IN THE UNITED STATES PATENT AND TRADEMARK OFFICE

SHOE AND LAST

APPEAL BRIEF

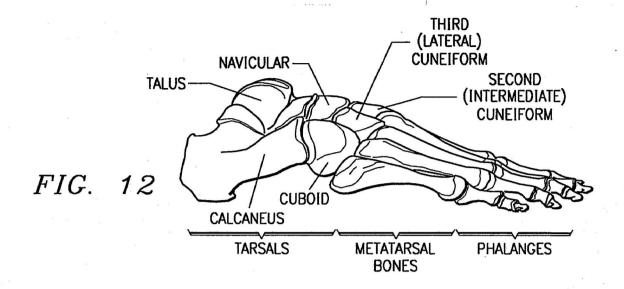
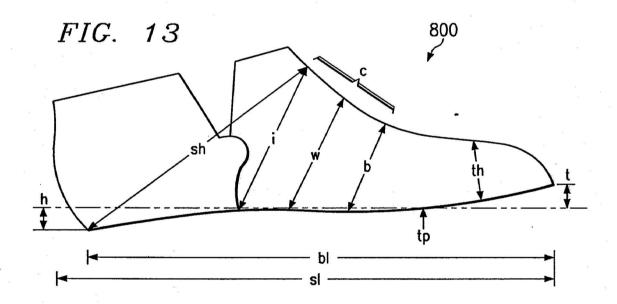
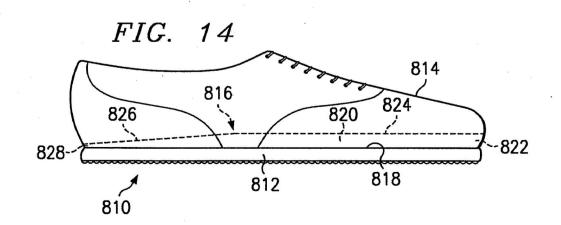
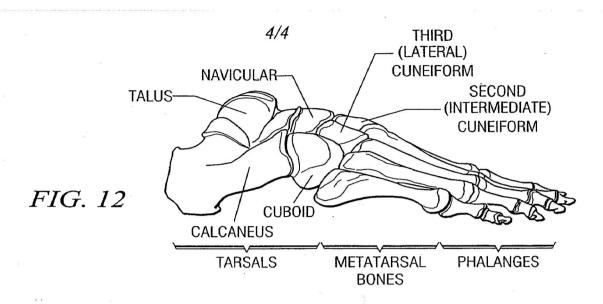
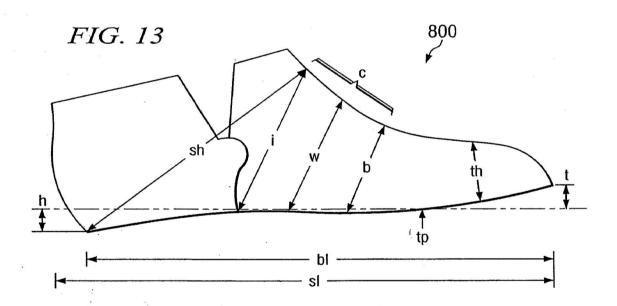
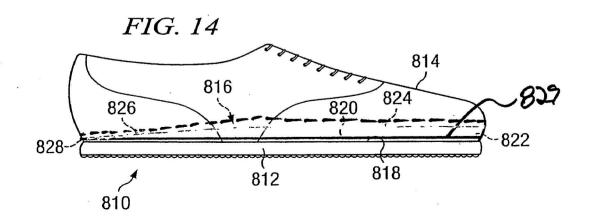
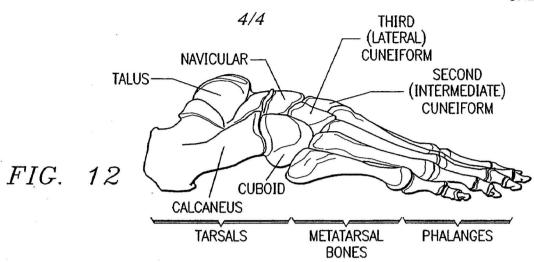
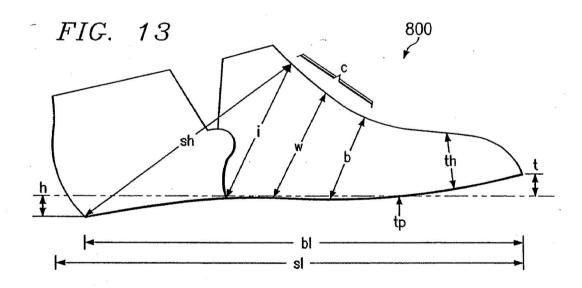
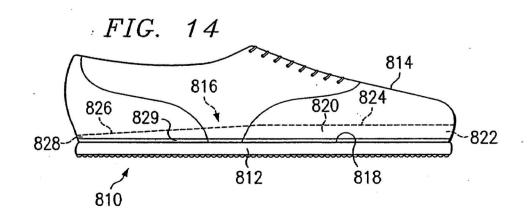
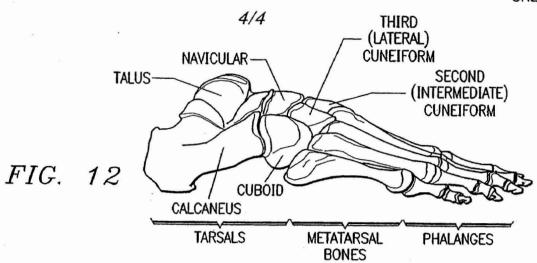
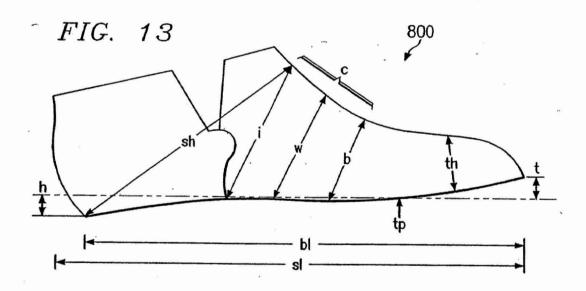
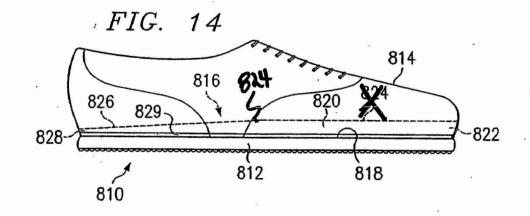
The drawings stand objected to under 37 C.F.R. showing every feature of the invention §1.83(a) as not specified in the claims. The Examiner has indicated that the drawing changes submitted to show every feature of the claimed invention, namely adding a midsole 829 and moving the location of point 824 where the first portion 820 and the second meet, constitute new matter. Applicant portion 826 respectfully traverses this objection.

In the Final Action of October 6, 2011, the Examiner objected to the midsole in the replacement drawing sheet as the thickness, shape, and exact location were considered to be Applicant's specification discloses new matter. thickness, shape, and exact location for a midsole at page 22, lines 7-12, and page 29, lines 11-13. In particular, specification states that the midsole provides cushioning, the shape of the midsole includes substantially planar surfaces, and the exact location of the midsole is between the insole Thus, the replacement drawing sheet the outsole. requested by the Examiner does no more than show a midsole well known to those of skill in the art separating an insole benefits of negative providing the claimed a configuration from an outsole as expressly disclosed Applicant's specification. The Examiner has improperly denied entry of the replacement drawing sheet on the grounds of new matter despite the more than ample support for the matter in As a result, the Examiner's Applicant's specification. disclosure matter beyond the insistence that new Applicant's specification has been added with respect to a Therefore, Applicant midsole is without justification. respectfully submits that the replacement drawing sheet does not contain new matter by the addition of midsole 829 and is in compliance with 37 C.F.R. §1.83(a).

With respect to the location of midpoint 824, Applicant has also shown that Applicant's specification clearly shows that the first portion 820 and the second portion 826 meet at a point 824 substantially halfway with respect to the upper or outsole of the shoe. (See page 29, lines Applicant's specification). Point 824 in the replacement drawing sheet is shown at the substantially halfway point of the shoe. The changes made to the drawings, as specifically required by the Examiner, literally track the exact language of Applicant's specification without deviation therefrom. Despite this express description of the location of point 824 being substantially halfway across a length of the shoe, the Examiner stated that the specification does not provide any basis for changing the location of point 824 to the specified location. as pointed out above, However, Applicant's specification expressly states the location of point 824 and thus the Examiner's reason that Applicant's specification does not provide any basis for changing the location of point 824 is without merit. Moreover, in the Decision on Appeal of March 1, 2010, the Board stated that the Examiner was amenable to the change of location of point 824. Therefore, Applicant respectfully submits that the replacement drawing sheet is in compliance with 37 C.F.R. §1.83(a) and no new matter has been added in accurately reflecting the location of point 824 pursuant to Applicant's specification.

2. Claims 1, 5-9, 11, 14-16, and 19-24 stand rejected under 35 U.S.C. §112, first paragraph, for failing to comply with the enablement requirement. The Examiner rejects the claims due to confusion between the specification and drawings as to a location of point 824 and the inclusion of a midsole 829. Applicant respectfully traverses this rejection.

The basis for this rejection is the apparent inconsistency between the specification and the original drawings. The claims have not been rejected for adding new matter. A proper replacement drawing sheet with amendments to FIGURE 14 has been submitted to clear up any apparent consistencies with Applicant's specification by showing a

For the convenience of the Board, attached herewith is a copy of the original drawing and a copy of the drawing changes made to accurately show the midsole 829 and the point 824. The drawing changes were made to provide consistency with Applicant's specification and do not add any new matter to the Application. Thus, there is no basis for the Examiner's position of new matter being added by the corrections made to

midsole 829 and point 824 substantially halfway across a Applicant's attempt to address any length of the shoe. inconsistency between the specification and drawings through minor changes to the drawings, changes expressly described in Applicant's specification, have been rebuffed for adding new matter. However, no justification has been provided for the Examiner's conclusion of new matter as the two minor changes to the drawings, the depiction of a basic midsole 829 and the point 824, are expressly provided location of Applicant's specification. Despite any inconsistencies, one of skill in the art would be able to easily make or use the invention provided in the claims from the subject matter described in Applicant's specification. Therefore, Applicant respectfully submits that Claims 1, 5-7, 11, 15, 16, 19, and 21-24 are in compliance with 35 U.S.C. §112, first paragraph.

See attached sheets showing original FIGURE 14 and drawing changes made to FIGURE 14 during prosecution of the Application. The drawing changes show a marked up copy and a clean copy for each change. The initial change to insert midsole 829 was included in a Response to Examiner' Action file January 7, 2005 in response to an Official Action issued October 7, 2004. The initial change to accurately show point 824 was included in a Response to Examiner's Final Action filed May 3, 2005 in response to a Final Action issued March 3, 2005.
